Product / Process Change Notification (PCN)	
<input type="checkbox"/> Major Change <input checked="" type="checkbox"/> Minor Change	
PCN Number: PCN_CDIP_CDIS_20240715 Affected Series: WPME-CDIP, WPME-CDIS Affected Order Codes: 18024x15401x, 18014x15401x, 18012x15411x PCN Date: 2024-04-15 (YYYY-MM-DD) Effective Date: 2024-07-15 (YYYY-MM-DD)	Change Category: <input type="checkbox"/> Equipment/Location <input checked="" type="checkbox"/> General Data <input type="checkbox"/> Material <input type="checkbox"/> Process <input type="checkbox"/> Product Design <input type="checkbox"/> Shipping/Packaging <input type="checkbox"/> Supplier <input type="checkbox"/> Software
Contact: Product Management Phone: +49 (0) 7942 - 945 5001 Fax: +49 (0) 7942 - 945 5179 E-Mail: pcn.eisos@we-online.com	Datasheet Change: <input checked="" type="checkbox"/> Yes <input type="checkbox"/> No Attachment: <input checked="" type="checkbox"/> Yes <input type="checkbox"/> No

Description of Change: <p>For the purpose of a datasheet information enlargement, Würth Elektronik has expanded the datasheet to include VDE reinforced and basic insulation safety certifications per the VDE 0884-17/DIN EN IEC 60747-17 standa

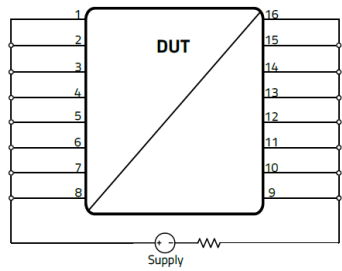
2. Corrected front page dimensions to accurately reflect the physical dimensions of the component.

18024x15401x, 18014x15401x	
Before Change	After Change
The digital isolator is available in an SOIC-16WB package (10.3 x 7.5 x 2.5)mm.	The digital isolator is available in an SOIC-16WB package (10.3 x 10.3 x 2.65)mm.

Figure 3: Dielectric test setup.

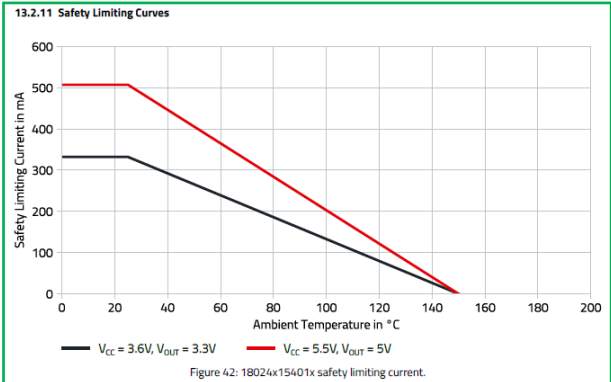
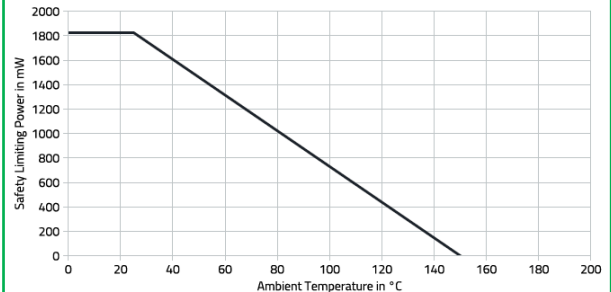
4. Removed Isolation Voltage chapter.

The entire section has been removed.
